An Independent Critique of Containment Loads Modeling Used in the Direct Containment Heating (DCH) Issue Resolution Effort*

David C. Williams

March 9, 1997

Figure 7-1. Hydrogen concentration and screening margin scaling parameters, ϕ_{H2} and ϕ_{sm} , for the Westinghouse plants with dry containments considered in NUREG/CR-6338 (Pilch et al., 1996).

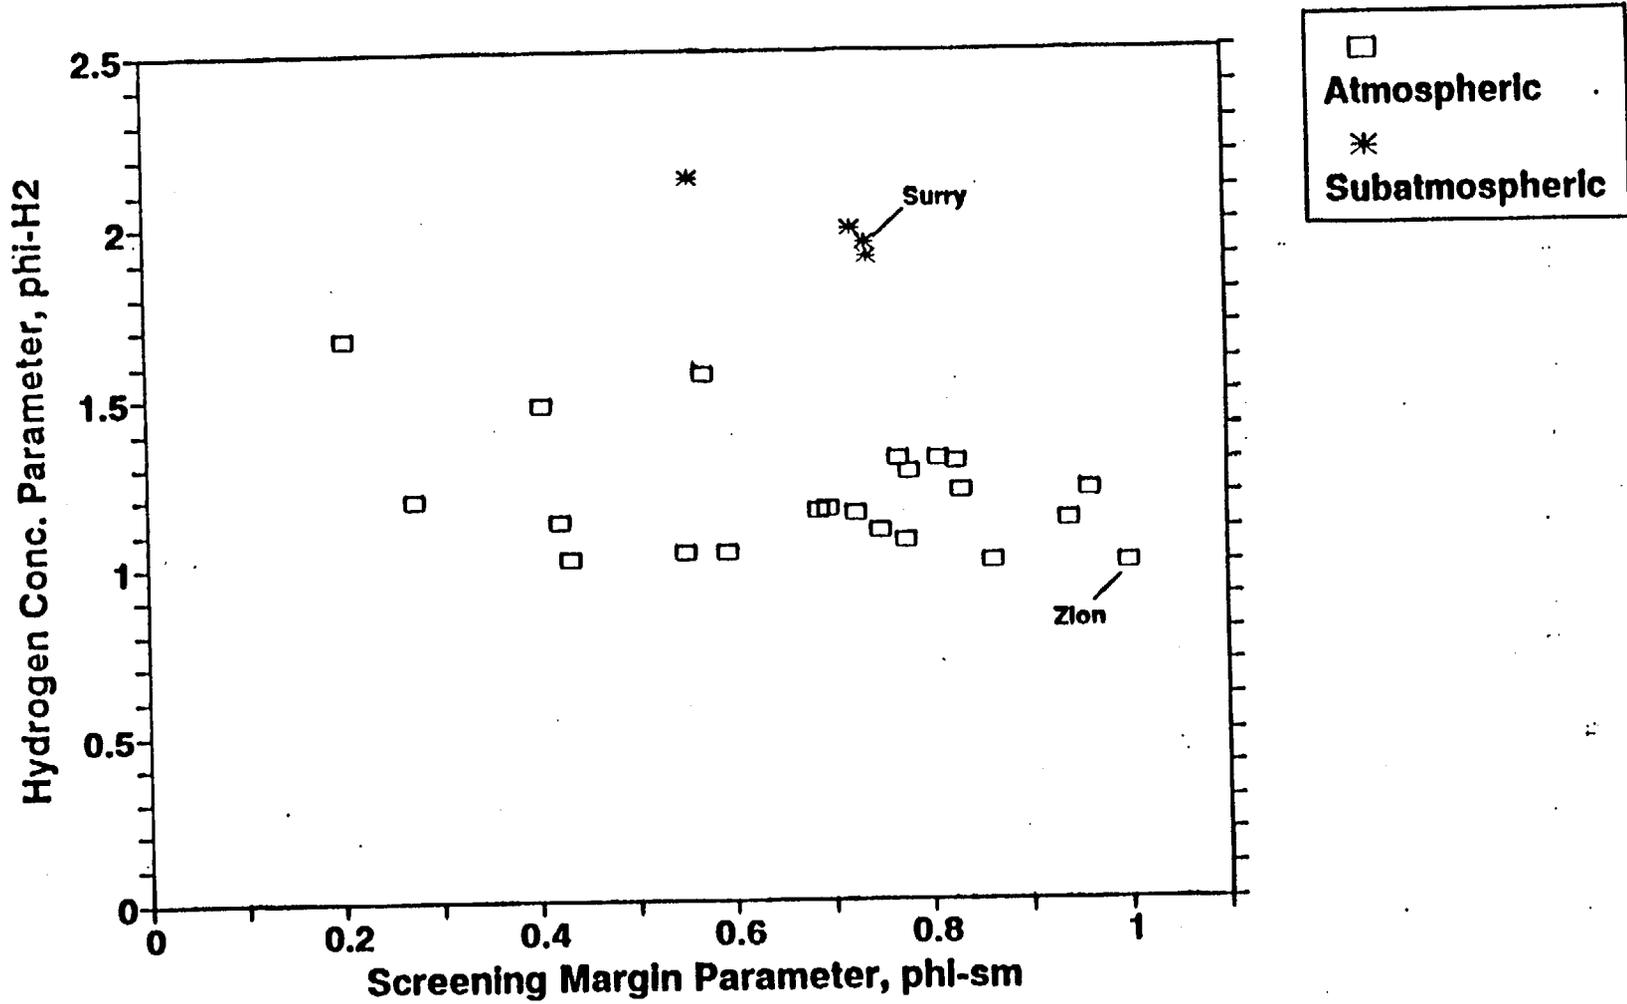
It is important that the significance of a small value of ϕ_{sm} not be misinterpreted. It does not necessarily mean that the plant has a containment that is particularly vulnerable to DCH loads. A very robust containment might still have a small value of ϕ_{sm} if the dependence of the CCFP on the pressure is very steep in the regime between $P_{0.01}$ and $P_{0.1}$.

For such a plant, the best estimate of DCH loads might be much less than $P_{0.01}$, in which case even a conservative allowance for phenomenological uncertainty in the loads modeling might not reverse the conclusion that DCH could be considered "resolved" for this plant. However, a small value of ϕ_{sm} does mean that simply demonstrating that the screening criterion of $CCFP \leq 0.01$ is met in the TCE calculations provides very little protection against phenomenological uncertainties in the loads modeling. Hence the screening methodology used by Pilch et al. (1996) is inadequate without refinements to take into account the variations in ϕ_{sm} . No such refinements were presented; in fact none of these questions were considered at all.

Figure A-4. Oxygen and hydrogen moles in the ANL/IET-6 and ANL/U2 experiments (Binder et al., 1994).

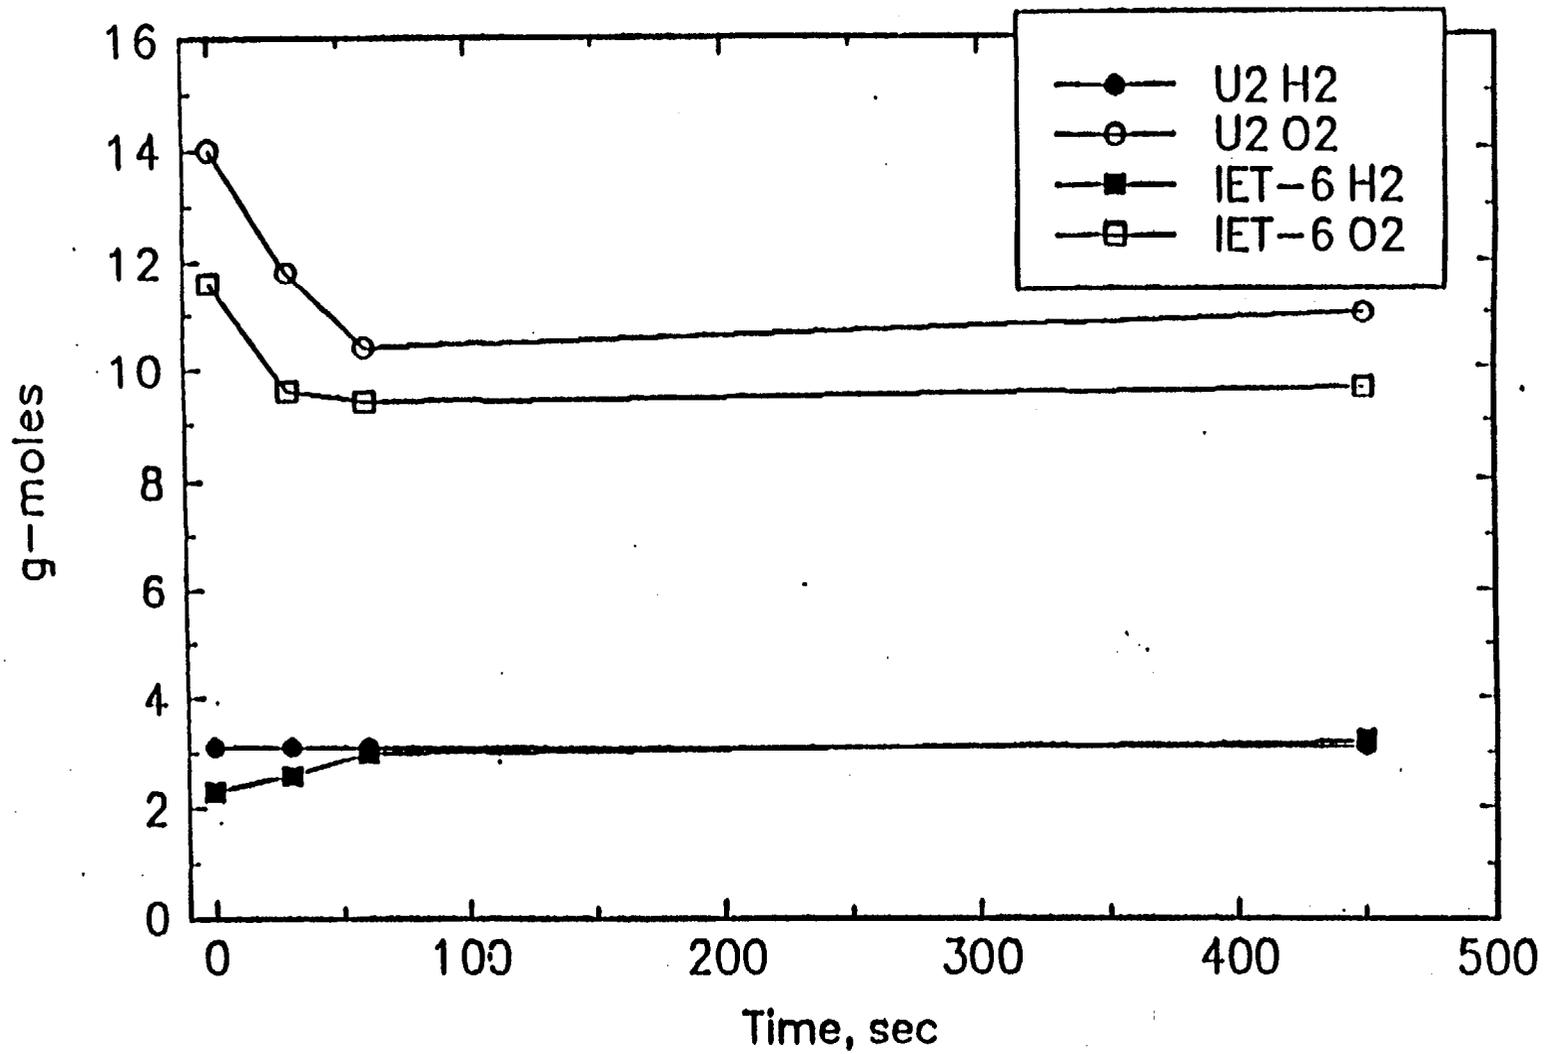
Binder et al. (1994) discuss the possibility of late reactions perturbing hydrogen measurements and present Figure 4.4 (reproduced here as Figure A-4) in support of this hypothesis. The oxygen results supposedly show evidence of a continued decline after the DCH event; since oxygen depletion is interpreted as representing H₂ produced and then burned in calculating hydrogen production, this decline would increase the apparent hydrogen production.

Actually, the results of the ANL/IET-6 experiment, in which the melt was the usual iron-oxide/aluminum thermite reaction product, show only a very slight decline (the first data point plotted in Figure A-4 is the pretest value; hence the decline between it and the next point includes the decline that occurs during DCH). The ANL/U2 experiment, which used prototypic core materials, does appear to show evidence of a continuing decline in oxygen inventory. However, there were two manifolds for gas collection in this experiment, and only the data from one of the manifolds (which are the results plotted) show this decline. The data tabulations given by Binder et al. (1994) of the detailed gas analysis results indicate that the other data series shows no evidence of a decline. Furthermore, these data show better time resolution, with the first sample being taken at only 5-6 seconds, versus 30-31 seconds for the data series showing the apparent decline. On the other hand, the data series showing the apparent decline does include replicate samples.

Figure B-4. Cavity pressurization history for the SNL/IET-6 experiment.

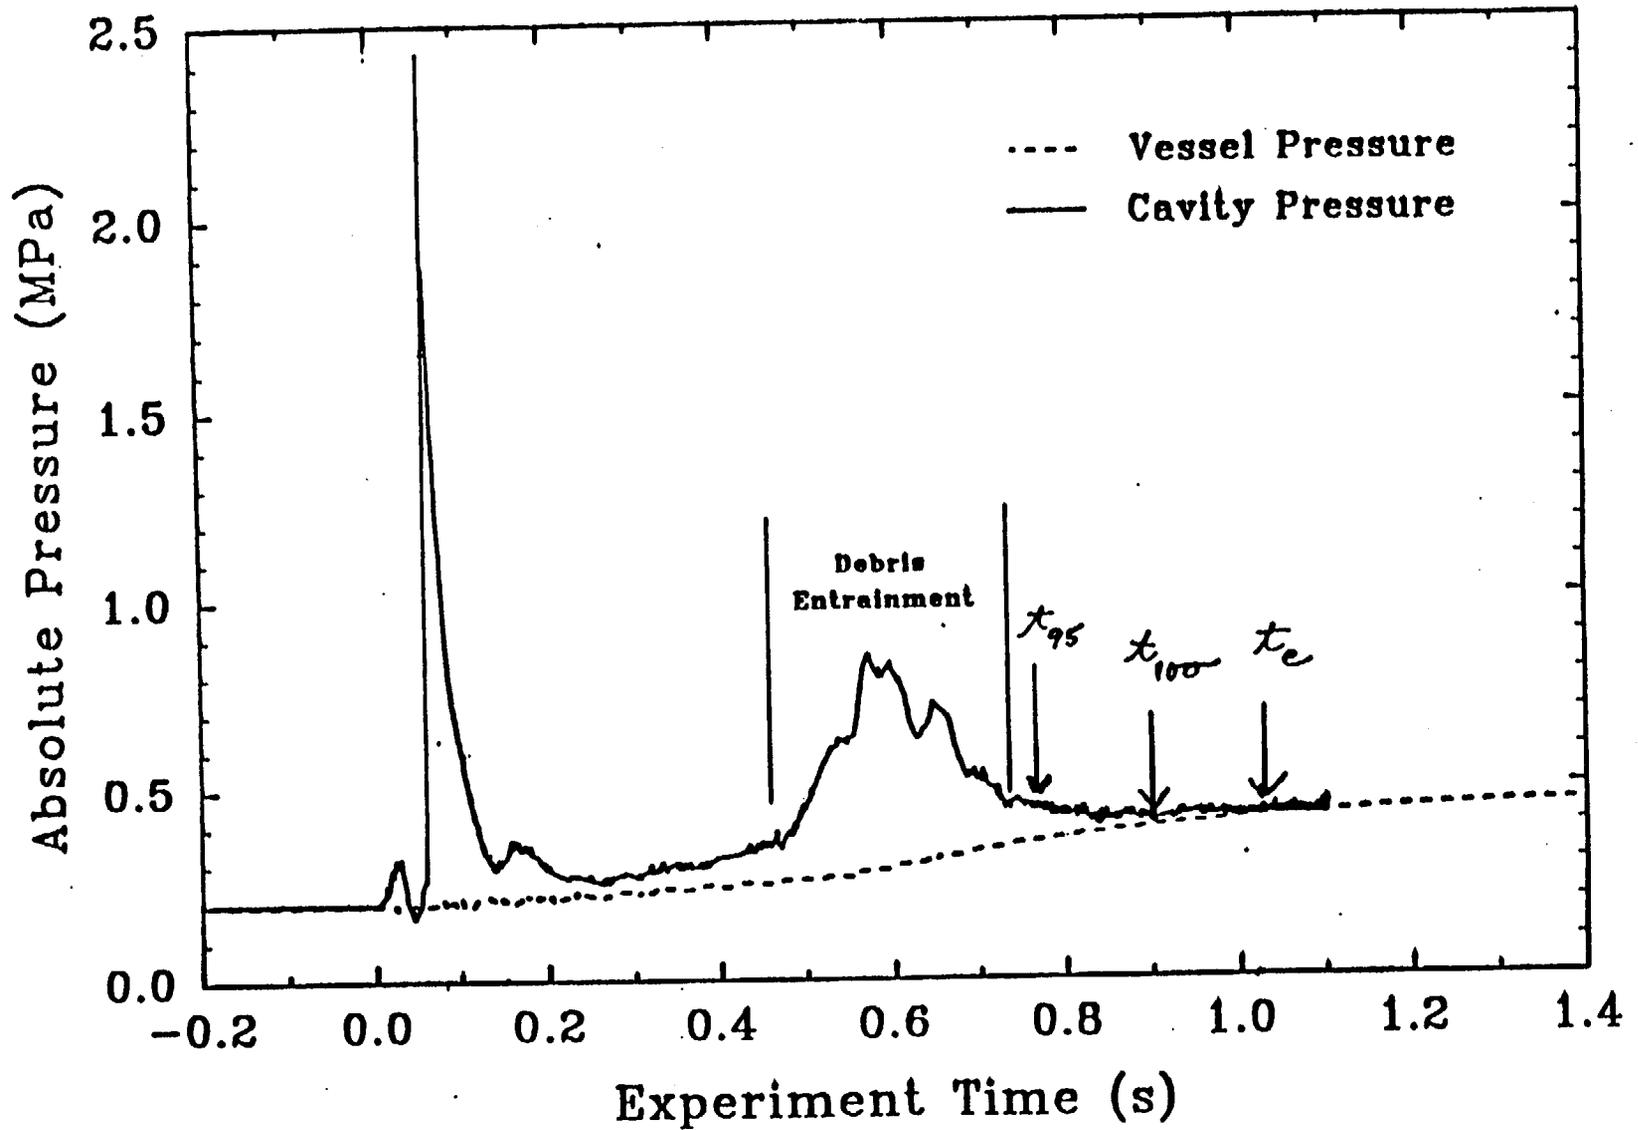
Even a casual inspection of these plots shows there is inconsistency in the treatment. For the SNL/IET-6 case (and also SNL/IET-3; see Figure B-6), the criterion for choosing the cut-off point appears to have been quite stringent; that is, all the tail is included in the coherence interval. (As an aside, one might question such a liberal allowance for the coherence interval because the steam entering the cavity during this time would see only the small amount of dispersed debris responsible for the tail. Note also that even the accumulator blowdown can produce some cavity pressurization. However, the main issue here is consistency.) On the other hand, for SNL/IET-1 and ANL/IET-6 the definition of the coherence interval is much less liberal, with a significant portion of the tail being excluded. The inconsistency is especially noteworthy for SNL/IET-1 and SNL/IET-6, since their cavity pressure histories are more nearly similar than is usually the case which should make it easier to define the cut-off consistently. It may be noted that, even with these values of t_c , TCE overpredicts SNL/IET-1 ΔP somewhat and underpredicts SNL/IET-6 slightly; a more nearly consistent treatment would worsen agreement for one or both of these experiments.
